**GENOA CHARTER TOWNSHIP
PLANNING COMMISSION PUBLIC HEARING
APRIL 8, 2024
MONDAY
6:30 P.M.
AGENDA**

Attention:	Amy Ruthig, Planning Director
Subject:	Pinnacle Wealth Management – Special Land Use and Site Plan Review #3
Location:	5311 Brighton Road – north side of Brighton Road, between Chilson and Bauer Roads
Zoning:	MUPUD Mixed Use Planned Unit Development

At the Township’s request, we have reviewed the revised submittal from Pinnacle Wealth Management to convert the use of and expand the existing building, and to hold events with music on an outdoor patio for the property at 5311 Brighton Road (cover sheet dated 3/12/24).

SHEET TITLE
PHOTOMETRIC CALCULATION
SITE

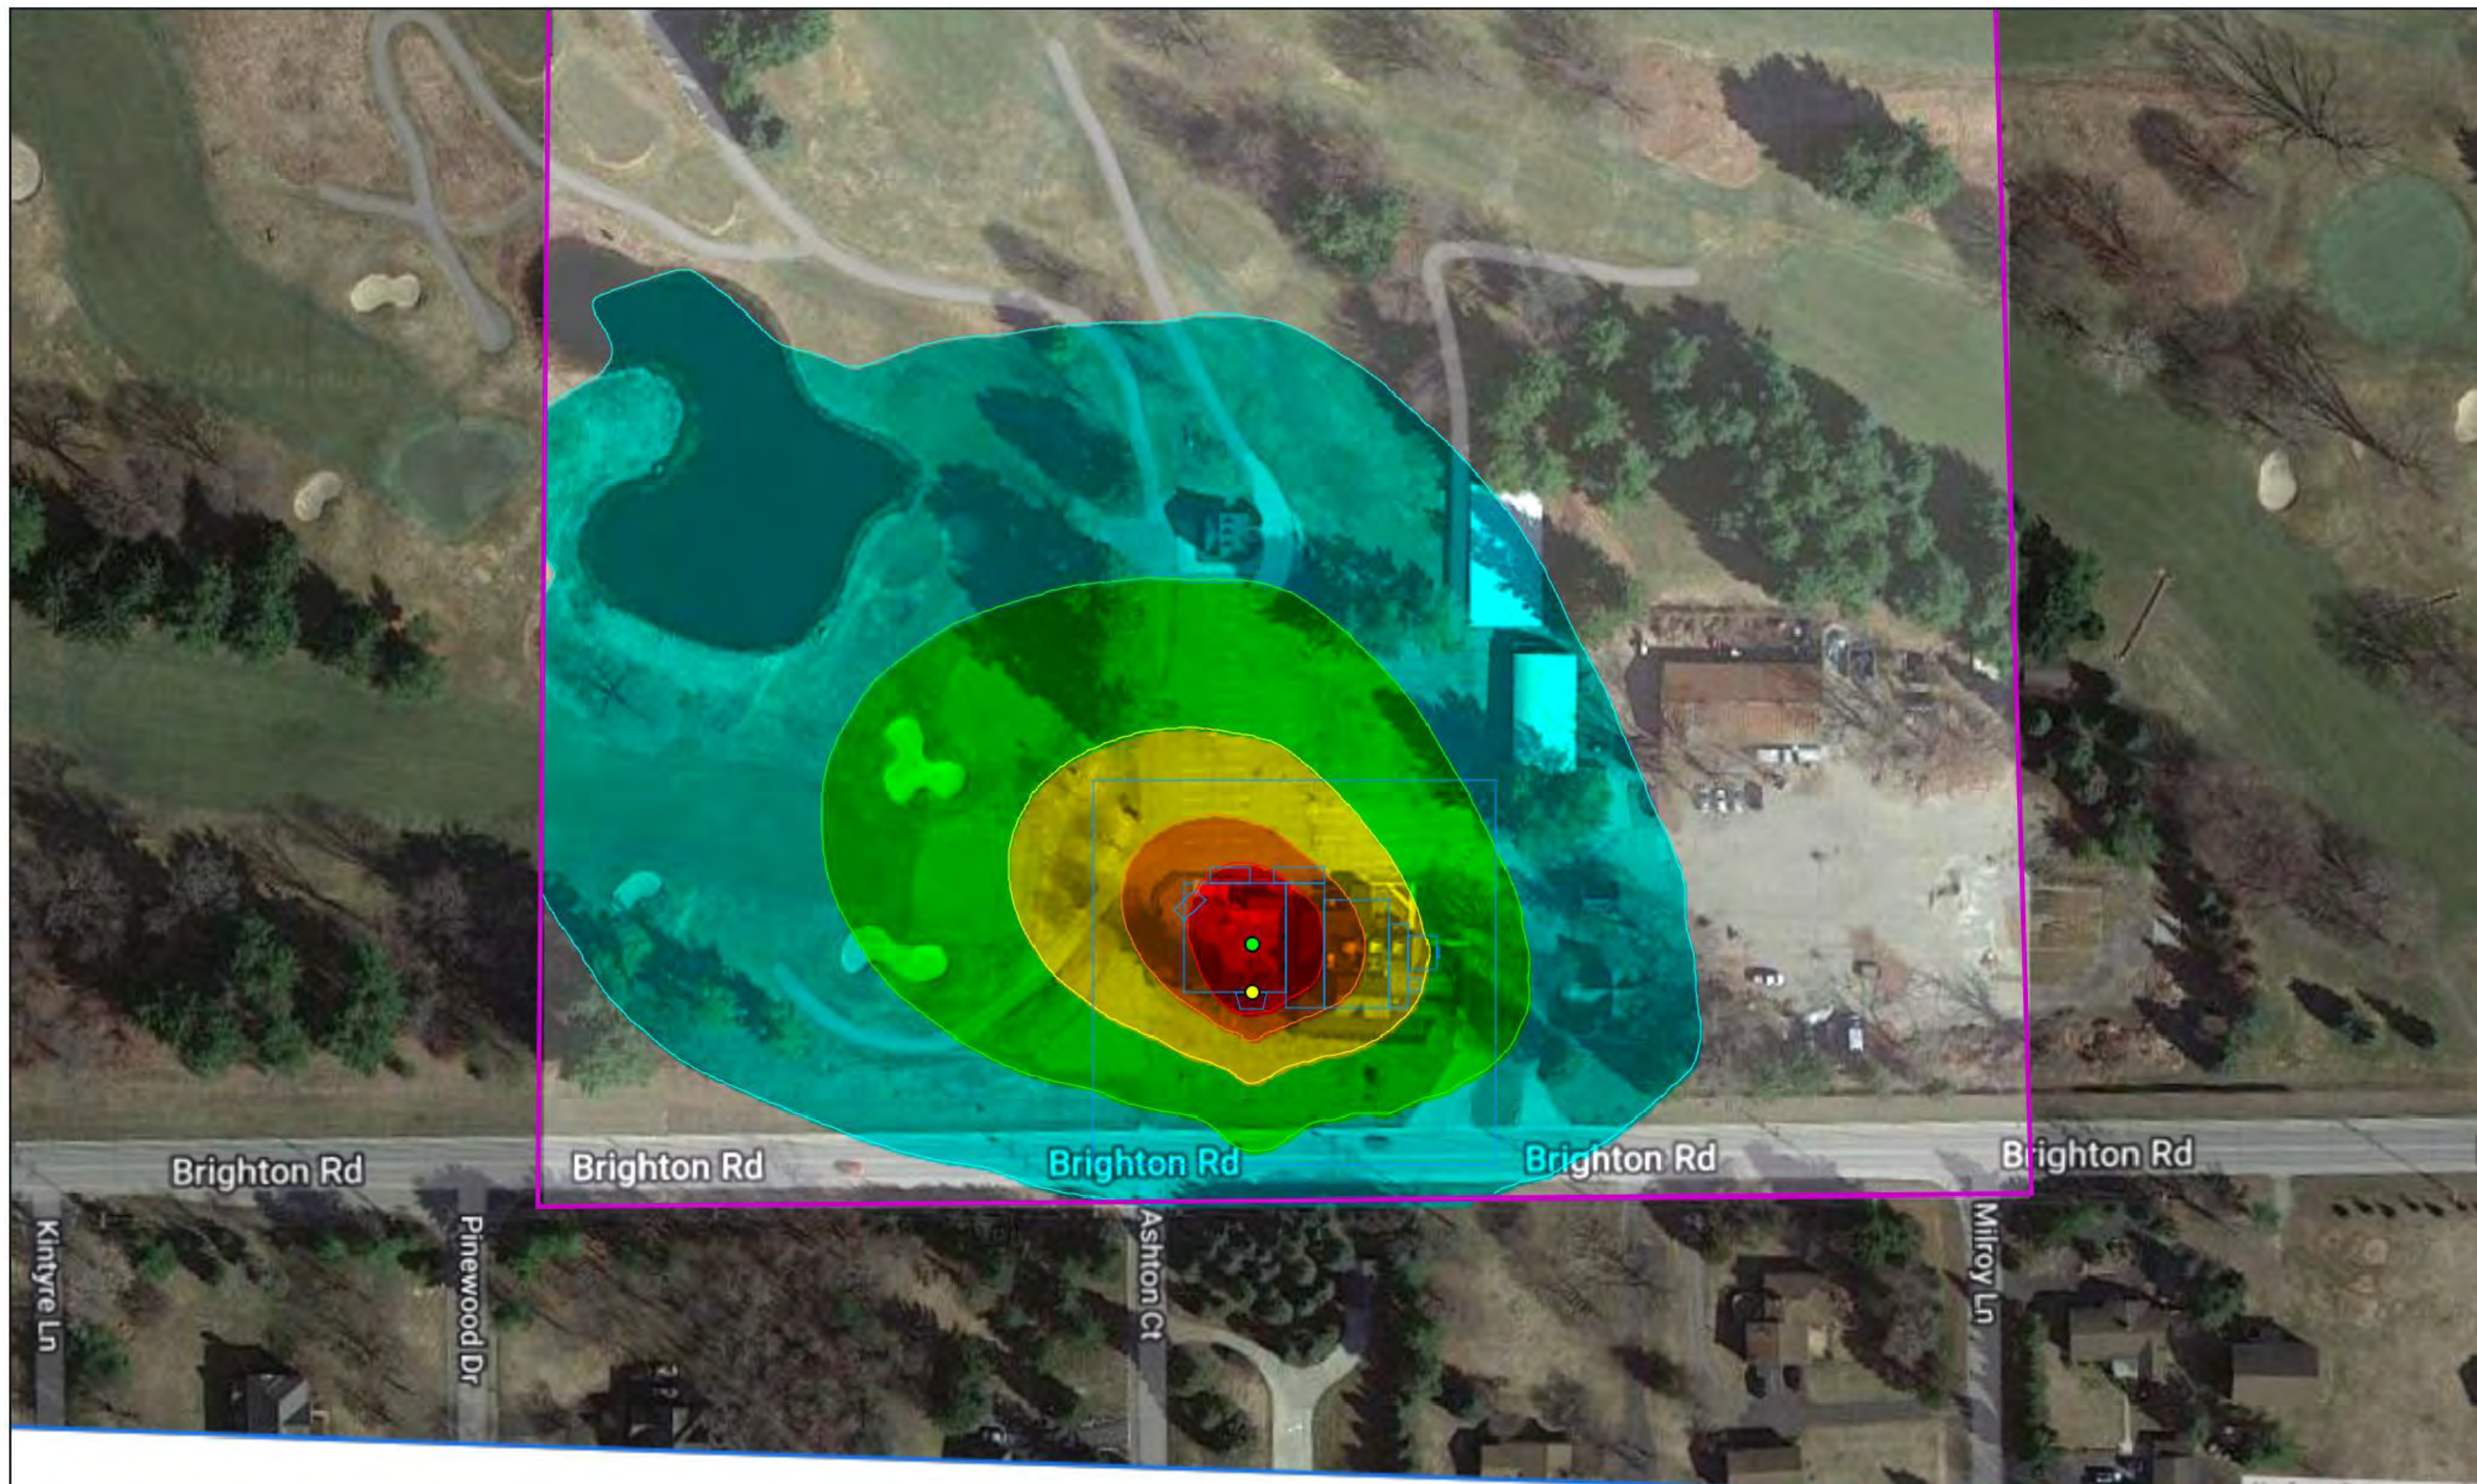
- g. We request the applicant confirm that the fixtures are downward directed and cut-off.
- h. If lighting is proposed for the outdoor patio area, details must be added to the lighting plan.

- 6. Exterior Lighting.** The lighting plan identifies 9 light poles in the parking lot and along the east side of the building. Mounting heights and light intensities comply with Ordinance standards; however, the fixture detail sheets are for a somewhat unusual decorative fixture. We request the applicant confirm that the fixtures are downward directed and cut-off.

It is also worth noting that the lighting plan does not show any illumination for the outdoor patio area. If lighting is proposed for this area, it must be added to the lighting plan.

Lastly, the Impact Assessment notes ornamental wall mounted lighting; however, the lighting plan does not identify any wall mounted fixtures. These details must also be added to the plan.
